ADDENDUM NO. 1

Project Designation: 16070 - JJSD #251 Harwood Elementary Addition and Remodel

For: Jefferson Joint School District No. 251

Date: April 29, 2019

DRAWING NO.:
A7.2

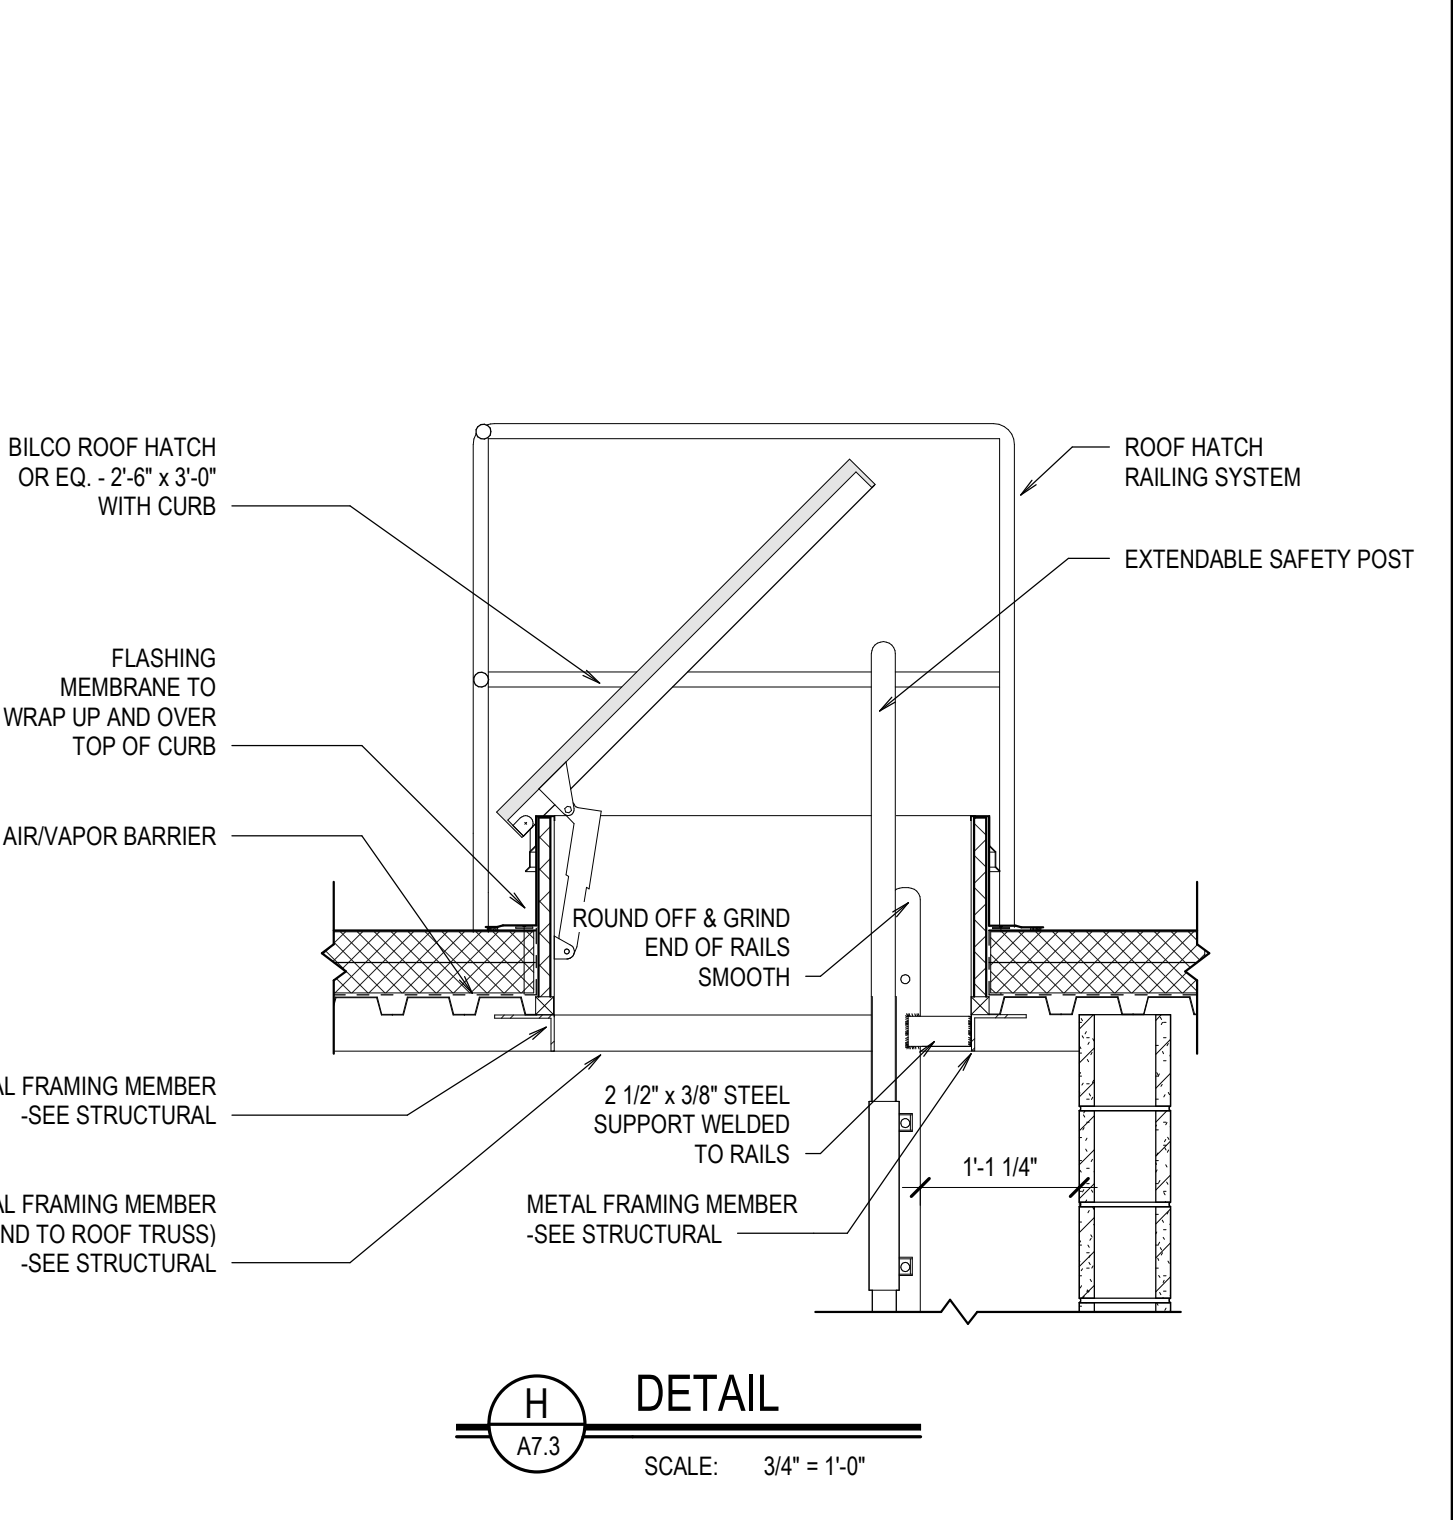
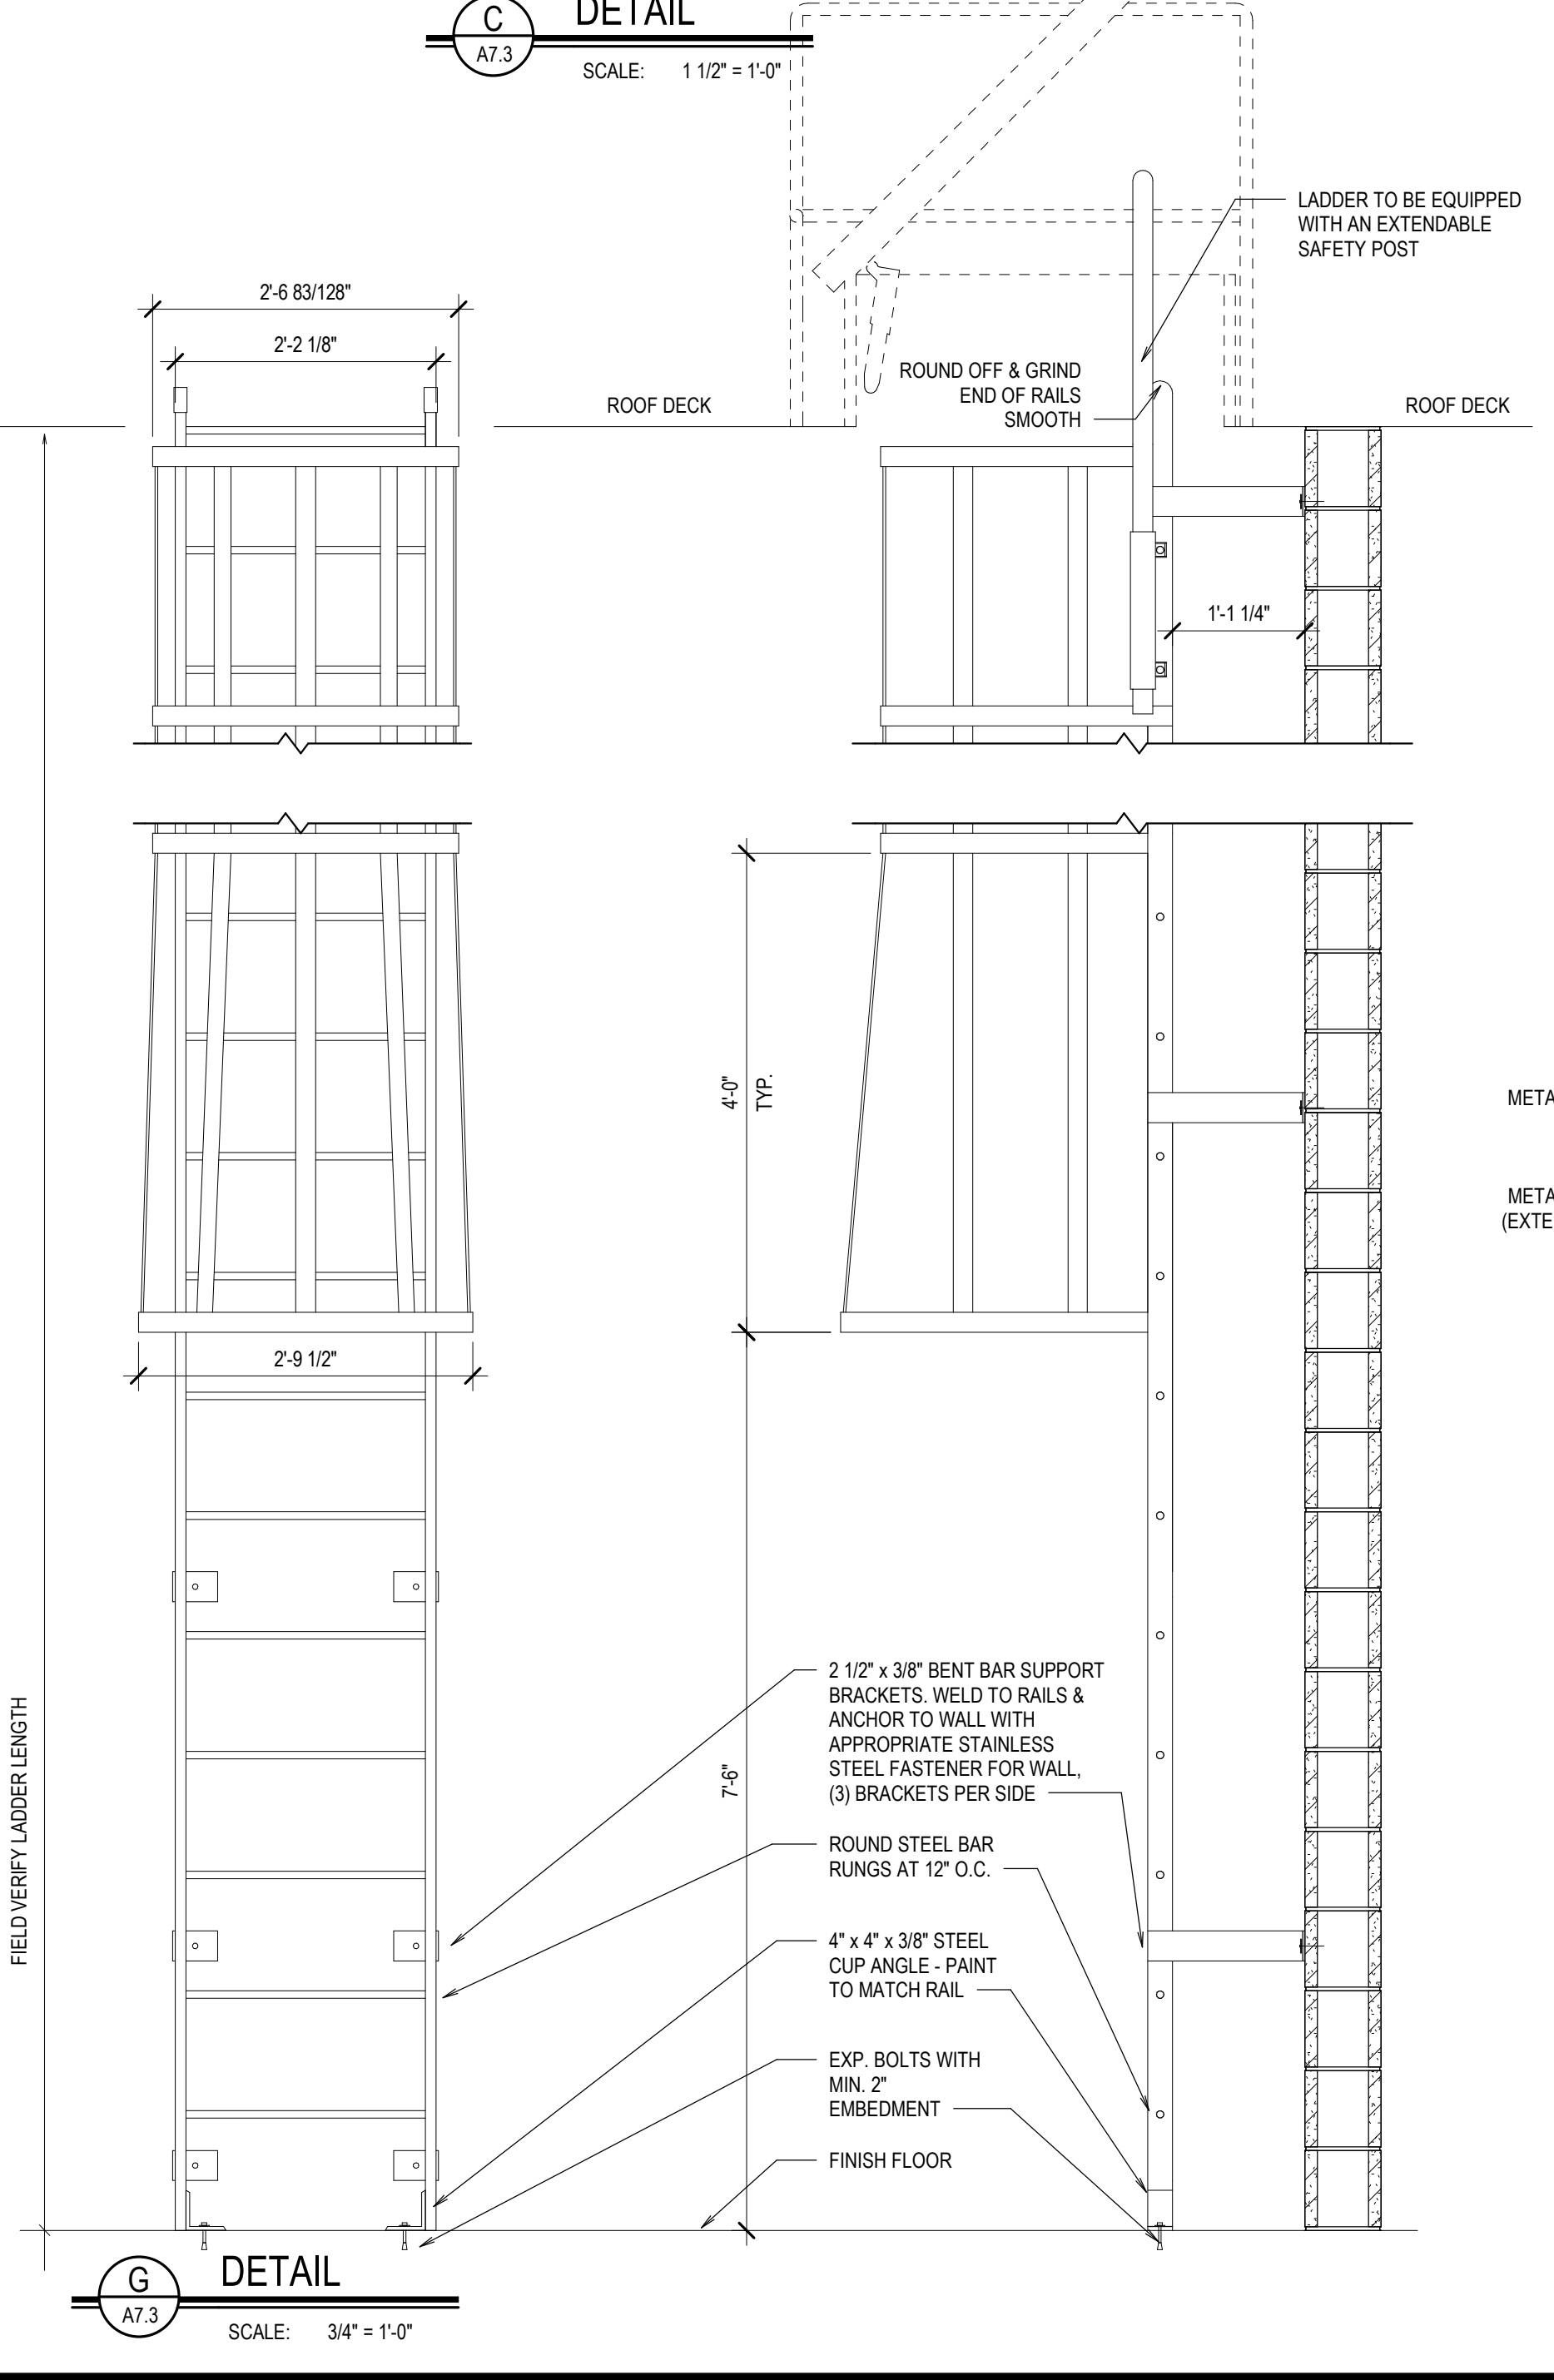
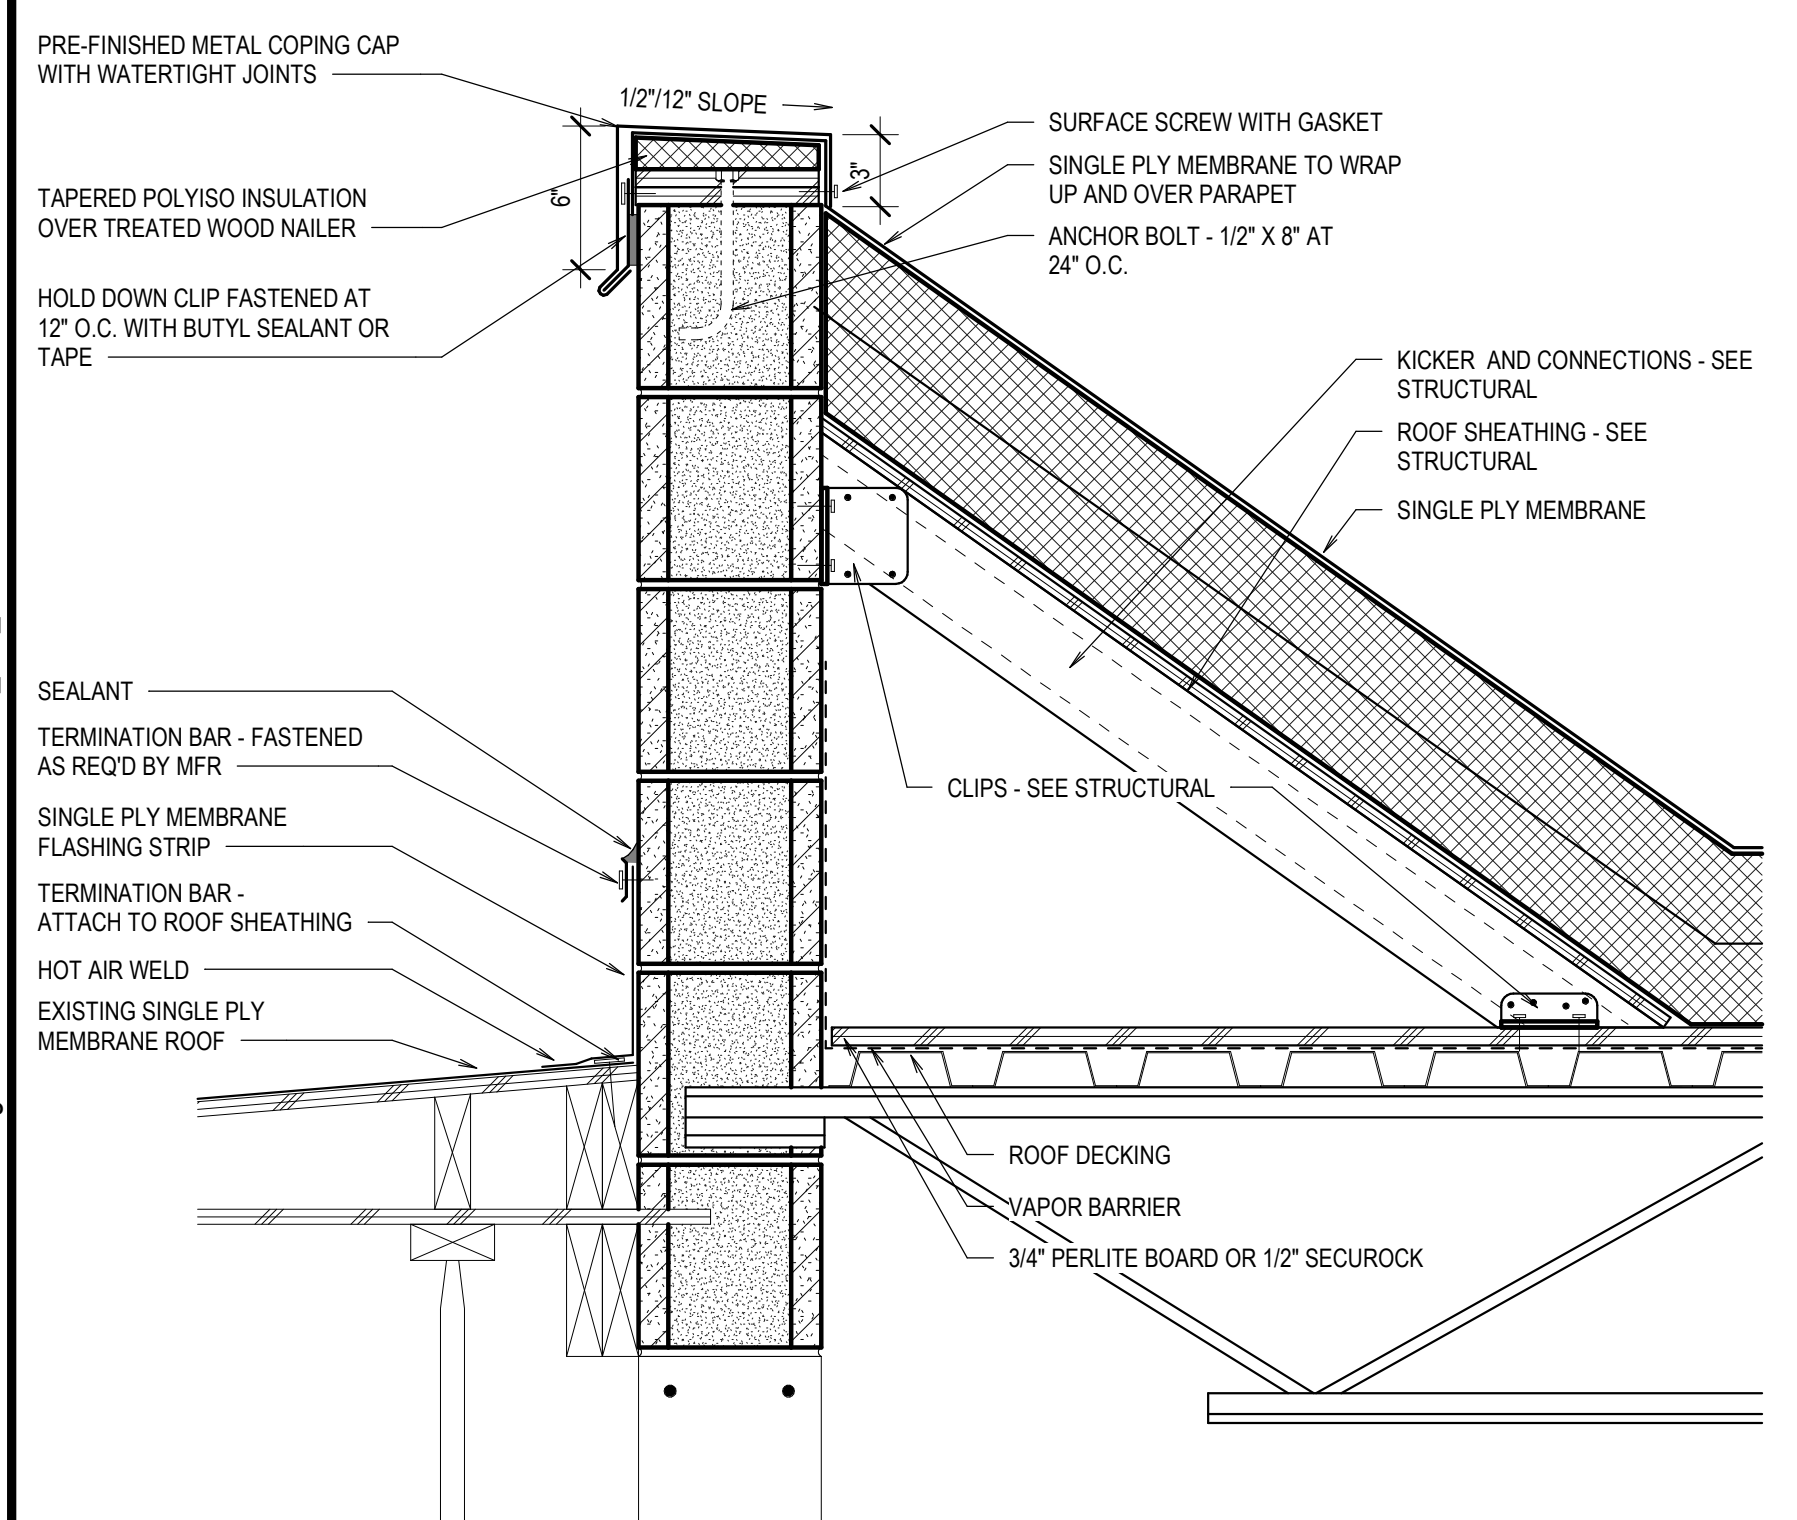
11. See revised sheet **A7.2 – 7.3**
 - a. Added 1/2" Securock as an option instead of Perlite Board to all roof details.
